Job Name: North Littlehampton
Job No: 39878
Note No: TN003 Rev. A
Date: 29.09.21
Prepared By: Alex Wray
Subject: Site-Wide Flood Compensation

Job Name: North Littlehampton
Job No: 332510715
Note No: TN004
Date: April 2022
Prepared By: Alex Wray
Subject: Response to Environment Agency Objection dated 24th January 2022

**FURTHER INFORMATION - APPROVAL OF RESERVED MATTERS FOLLOWING
OUTLINE CONSENT LU/47/11/ (AMENDED UNDER LU/182/15/PL) FOR THE
FORMATION OF THE CENTRAL WETLAND AREA AND THE CONSTRUCTION OF
THE CENTRAL SPINE ROAD RUNNING ACROSS THE CENTRAL WETLAND
AREA, LINKING UP PHASE 5 AND PHASE 2B (ALSO KNOWN AS PHASE 4).**

Project No. 39878	Scale 1:2000
Revision	Drawing No.
D	4001/008

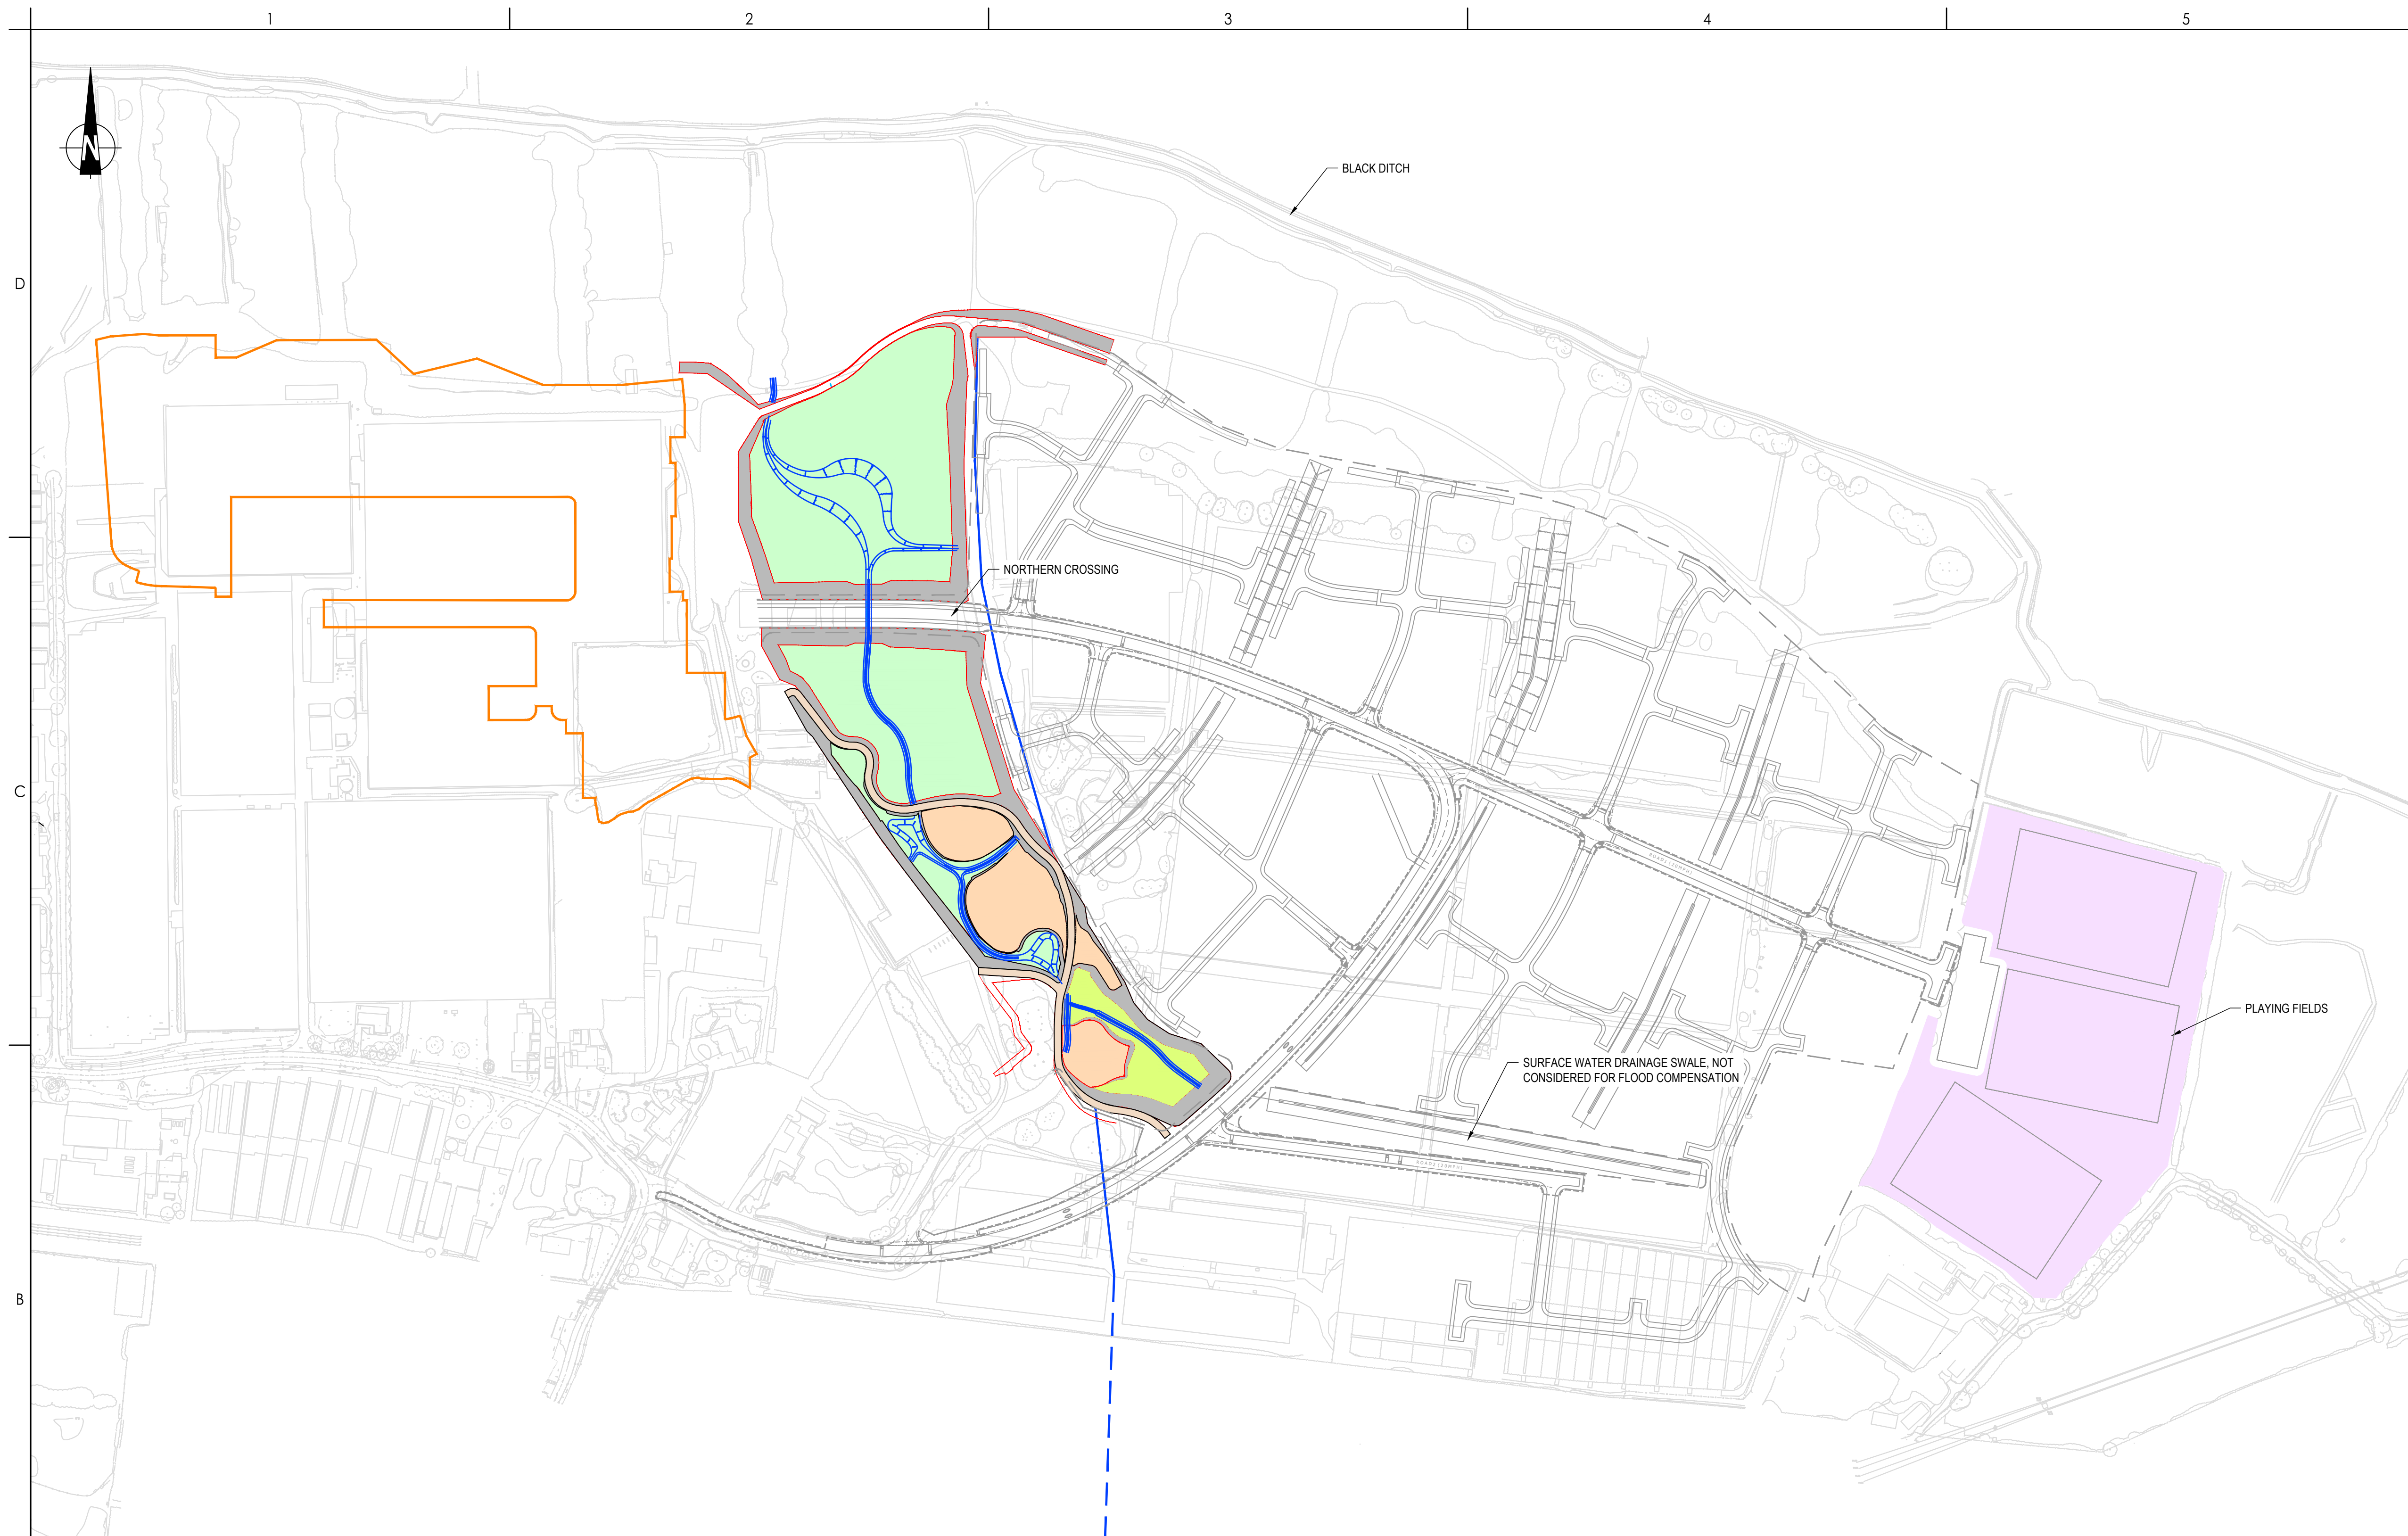
The flood plain compensation proposed with this planning application will only create 324m³ additional storage, which is considerably lower than the 27,300m³ proposed at the outline planning application, which was one of the reasons of the removal of the Environment Agency (EA) initial objection.

It looks like the majority of the compensatory storage area is within Flood Zones 2 and 3. This is an inappropriate location for a compensatory storage area as this land would be expected to flood in the design event. Digging down into this land would not provide the designed compensation volume as the soil would be saturated and area would be expected to fill with water anyway. Compensatory storage areas should be providing flood storage outside of design flood extent.

The calculations provided in table 1 of the Technical Note show loss of storage at the lower and higher levels. To be an acceptable compensation scheme, the volume of flood gained in each particular slice should be greater than the volume lost for that same slice.

The recent review of the latest proposals has allowed the refinement of the analysis to include the final CWA form, including the free-flowing low-level drainage ditches. This analysis also identified that there were minor corrections to be made to the triangulation of the ground model. The result of this has now been included in the table below as well as on our revised drawing 39878/4001/008 Rev. D and identifies modifications at all bands.

As a result of the update, the current design shows significant overall gains in storage of 8193m³ across the site, which is closer to the original FRA figure.

Following the review of the ground model and proposals outlined in our response to point 2 above, the level-for-level losses at the low levels have been updated. With regards to the principal concern at the lower levels, the revised analysis shows gains in the lowest bands with a small loss within a single band. Table 2 below shows the cumulative flood storage for all bands as a result of the flood compensation, demonstrating positive storage throughout.

.As discussed in the call on the 15th March, the original FRA was accepted on the basis that it did not provide a level-for-level compensation scheme. We have eliminated all but one band of loss within the lower bands and have reduced the losses at the lower risk higher bands significantly.

D	DRAINAGE DITCHES ADDED	HY	25.03.22
C	UPDATED WEILDAN AREAS	CS	29.09.21
B	PLANNING ISSUE	JFDS	20.12.18
A	INCORPORATION OF NEW CONSTRAINTS AND PLATFORM LEVEL INFORMATION	AW	02.05.18
Issued/Revision		By	Appd
			YYYY.MM.DD
		SMR	2021.09.30
	Dwnr.	Dsgn.	Chkd.
			YYYY.MM.DD
